Addendum No. M-02

Reference: Added Scope and clarification

Issue Date: November 6, 2024

Project: UHN TWH – SEM & Corridor (EXP Project Number MRK-23004289-A0)

1.1.2. M-004 – SNOW MELT SYSTEM – COURTYARD – SEM CENTRE

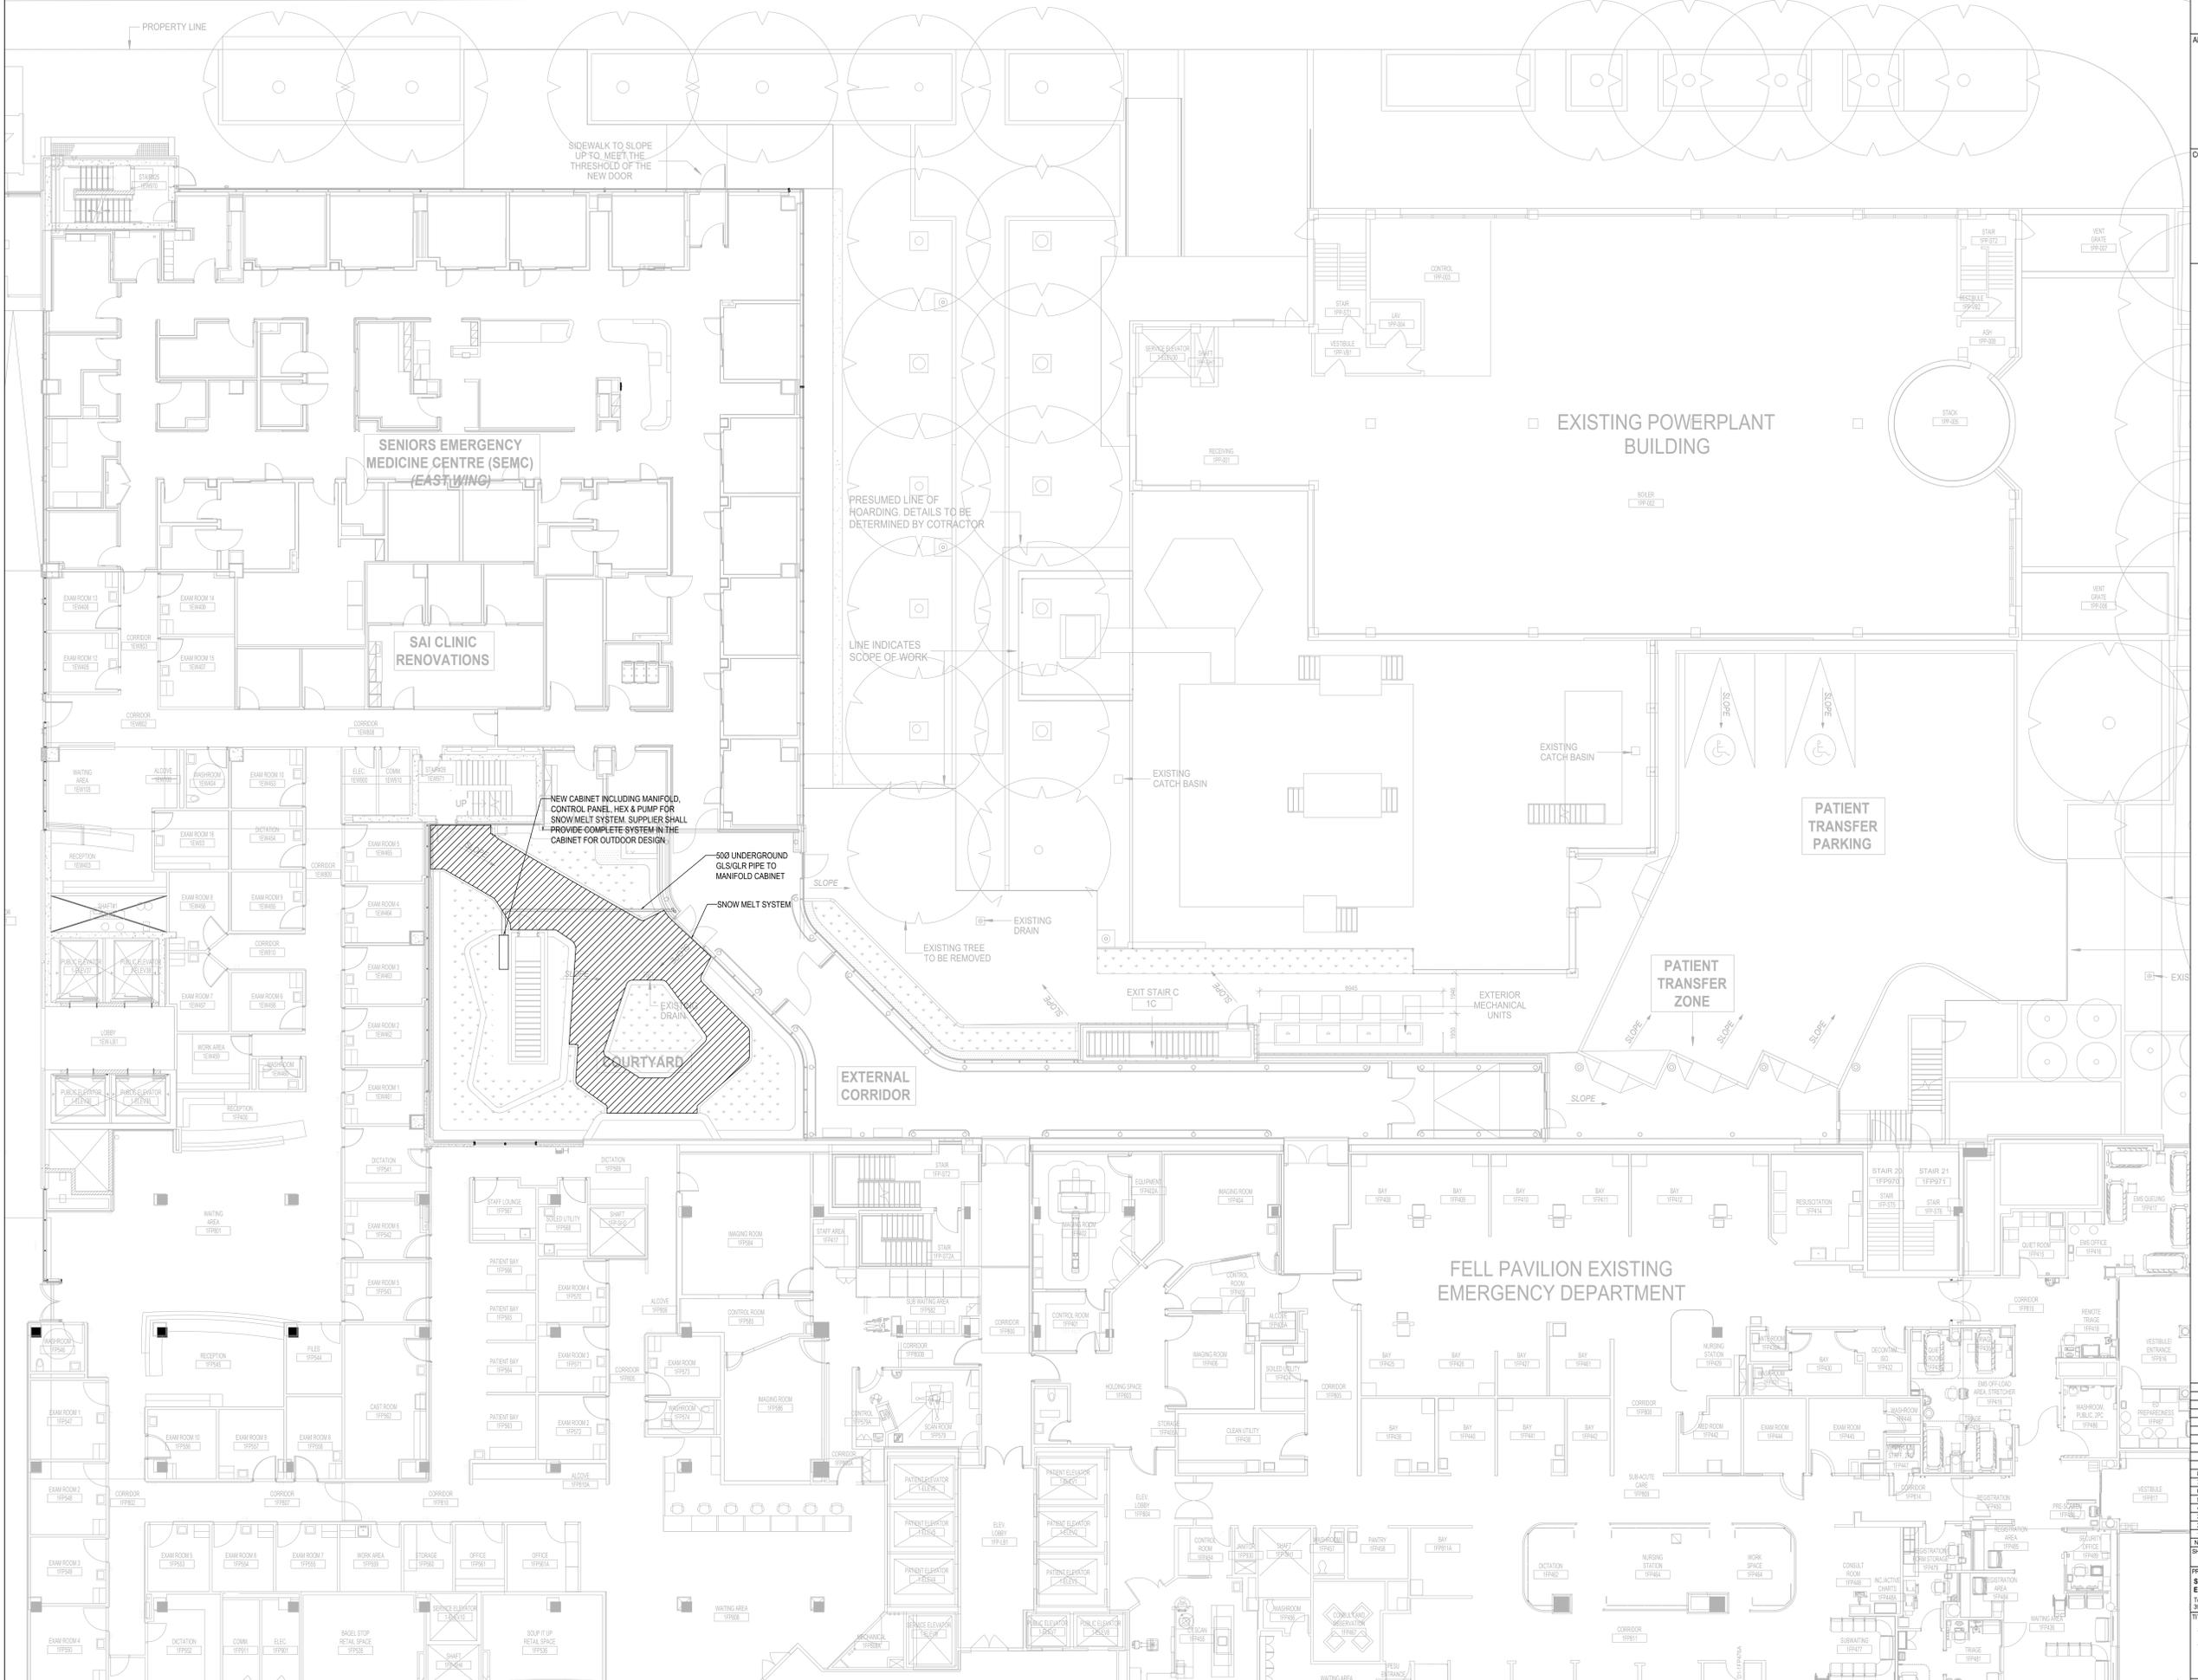
- .1 Added new drawing to show the snow melt system.

TITLE:
UNDERGROUND FLOOR PLAN - DEMO - PLUMBING

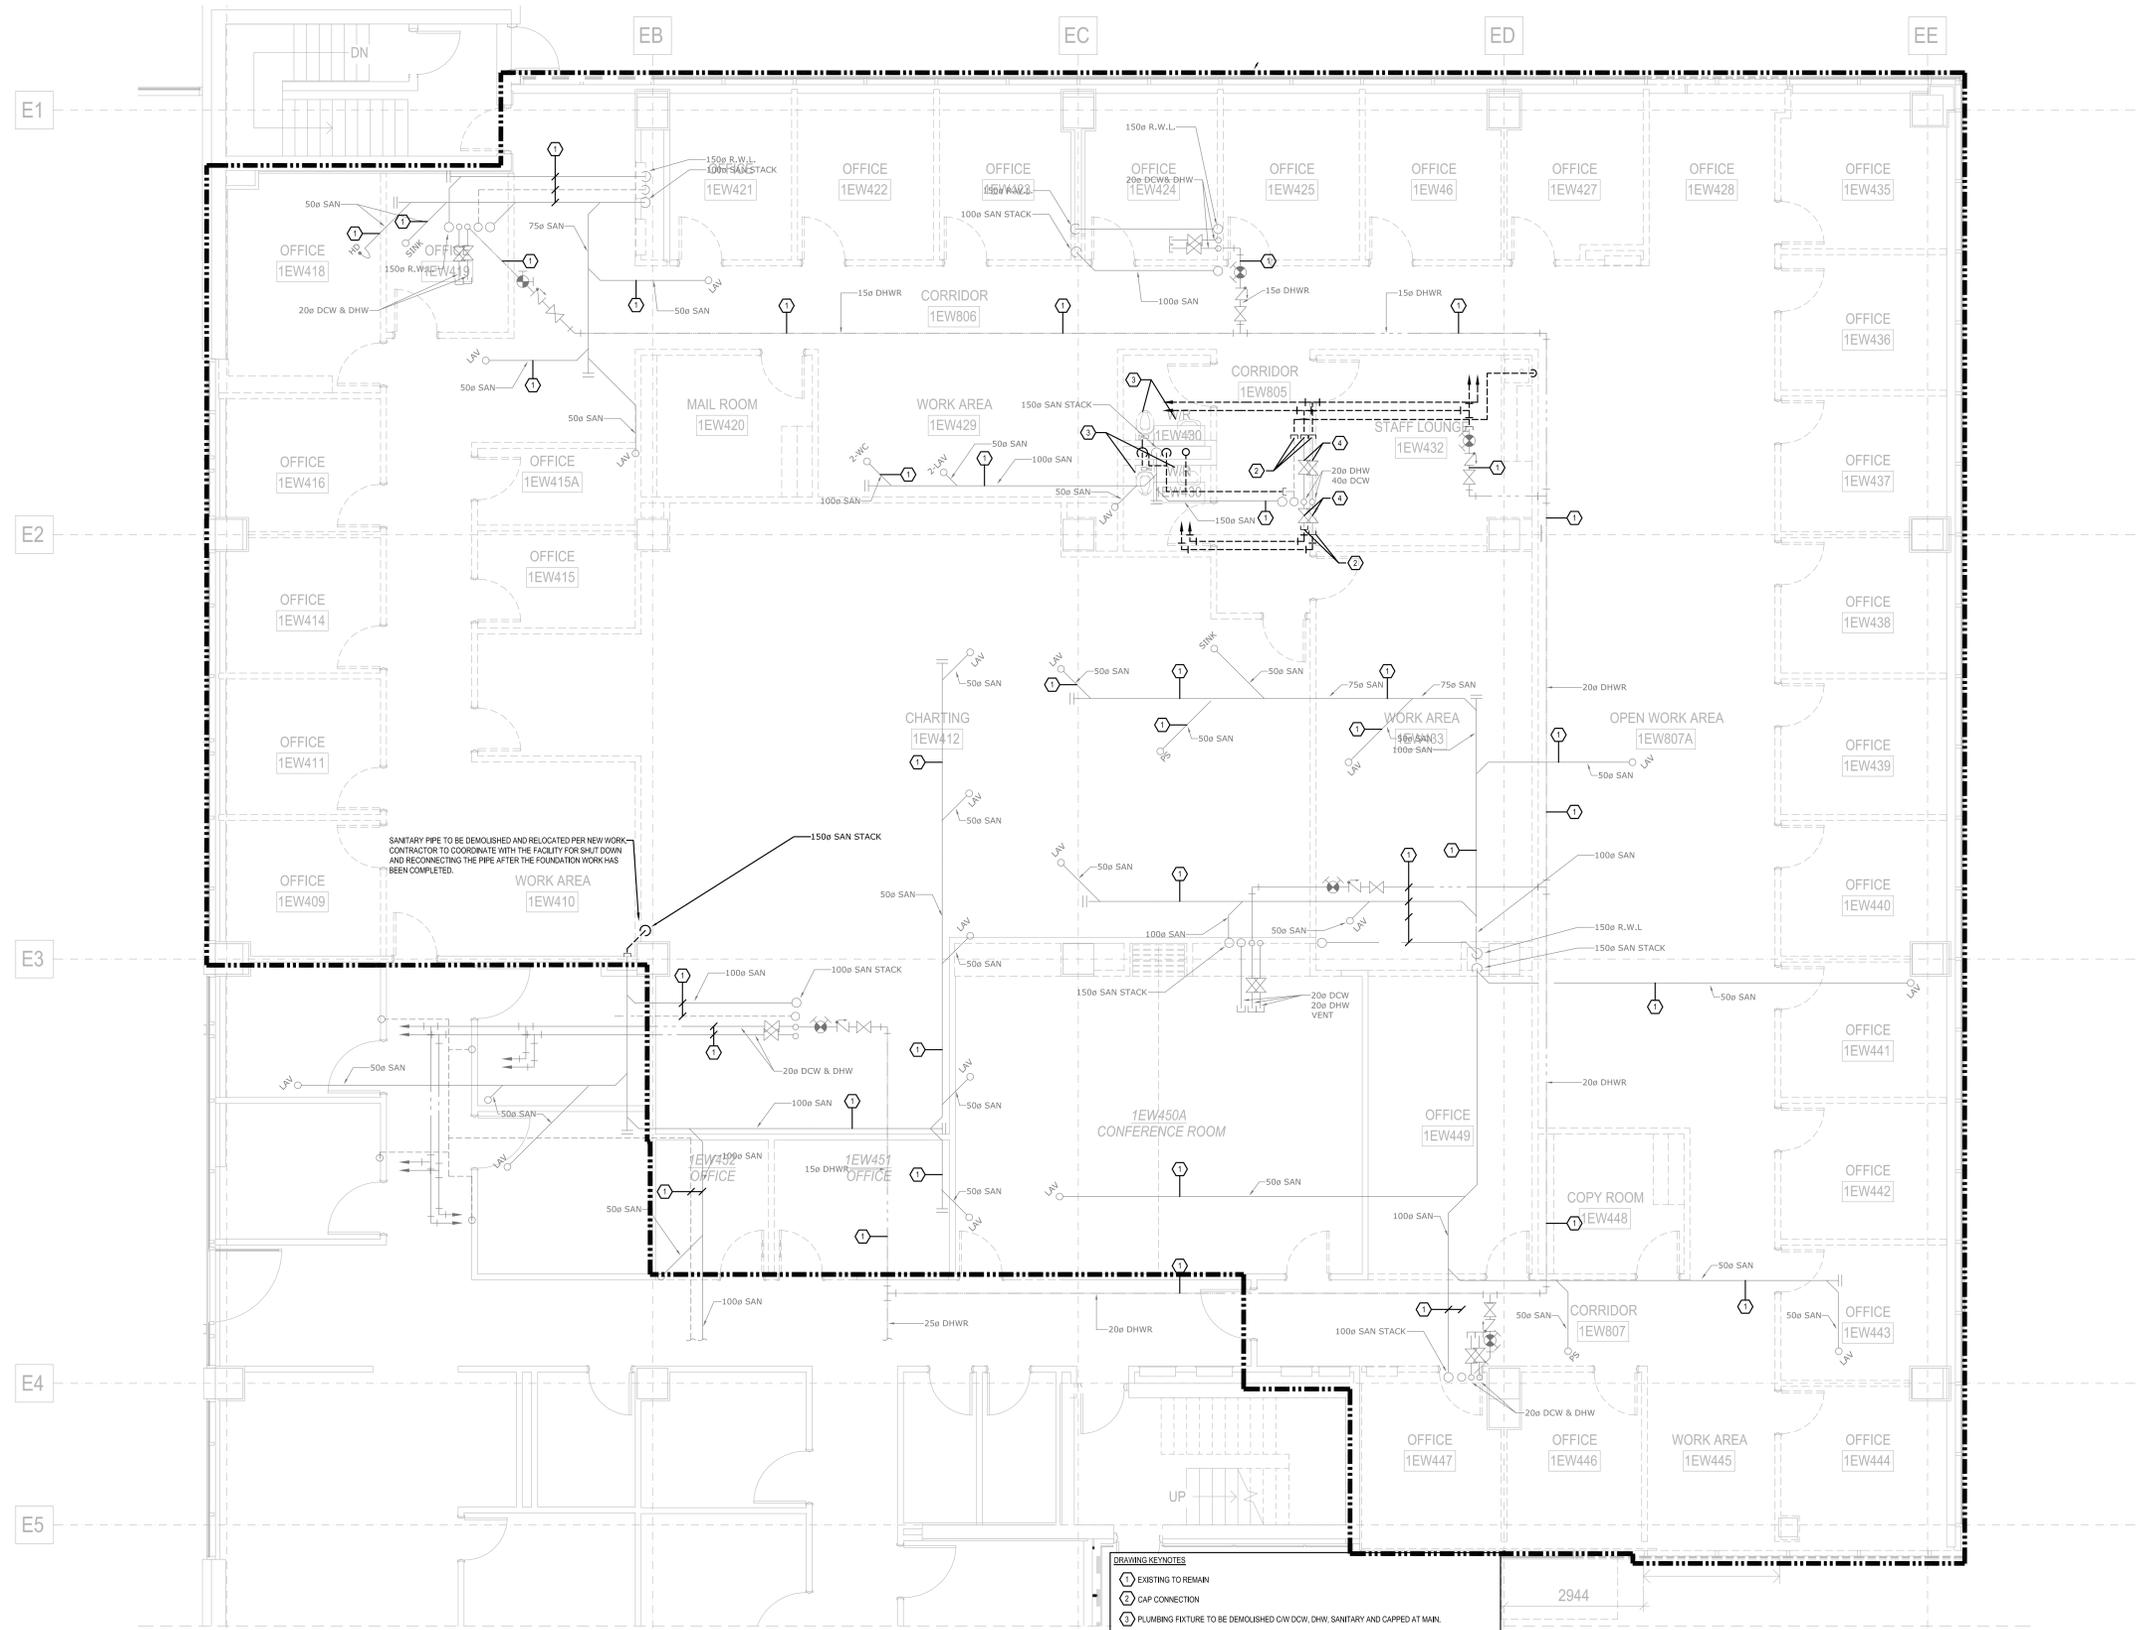
- 1.1.4. **M-101 – UNDERGROUND FLOOR PLAN – DEMO - PLUMBING**
- .1 Revised scope of work boundary.
 - .2 Added note to verify pipe invert and provide pipe protection for incoming water and fire pipes.
